Kwalsa Phase II Project (Big Silver)
System Impact Study Addendum
May 20, 2016

This is an addendum to the System Impact Study Report (No. T&S Planning2012-004 Kwalsa Phase II Project Interconnection System Impact Study) dated August, 2012.

Kwalsa Phase II Project

Report No: T&S Planning2012-004

Figure 1 – The Kwalsa Phase II Hydroelectric Project Interconnection Diagram

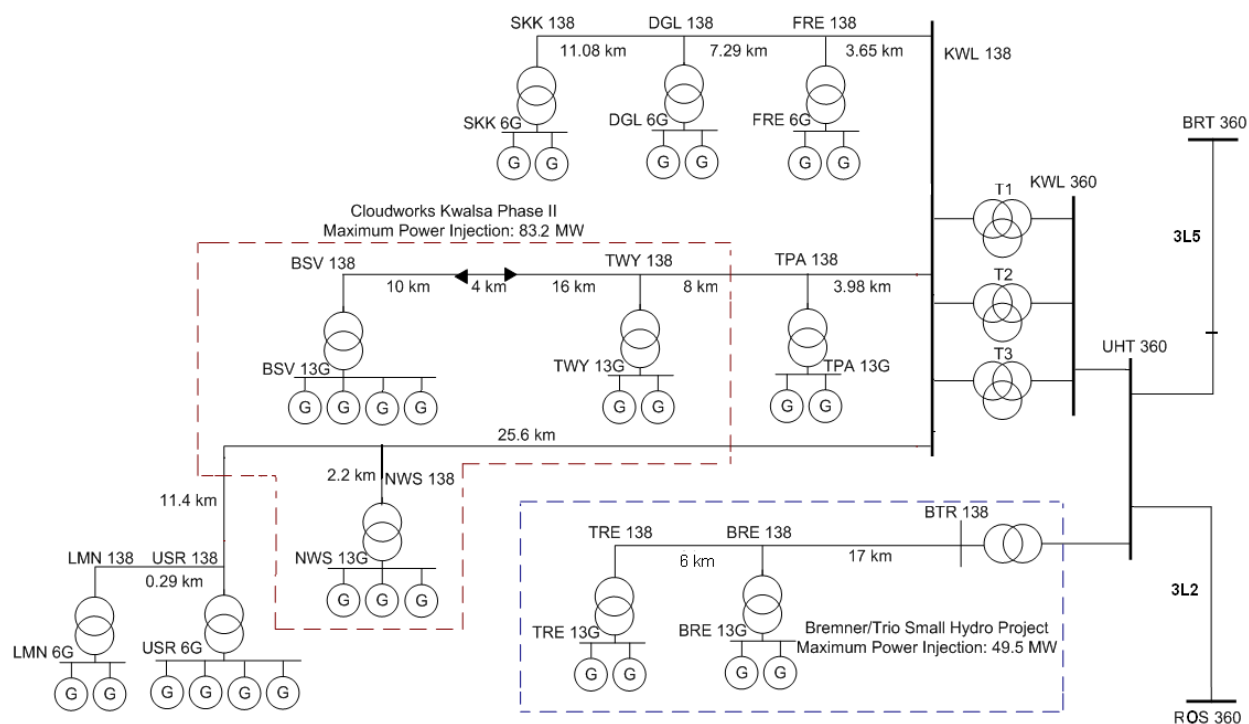
The IC's 138 kV transmission lines associated with connecting BSV to the IC's 138 kV transmission system in the new submission are slight different from those in the 2012 study. The sentences in the third paragraph of the Executive Summary and the same sentences in the last paragraph of Introduction of the 2012 SIS report:

"TWY will be connected to the existing 138kV line from KWL to Tipella generating station (TPA) at TPA via an 8 km overhead line. BSV will be radially connected to TWY via a 4 km submarine cable and two overhead line segments (10 and 16 km)."

Will be superseded by the following sentences:

"BSV will be radially connected to TWY via a 4.3 km submarine cable and two overhead line segments (8.3 and 14.8 km). TWY is connected to the 138kV line from KWL to Tipella generating station (TPA) at TPA via a 7.3 km overhead line."
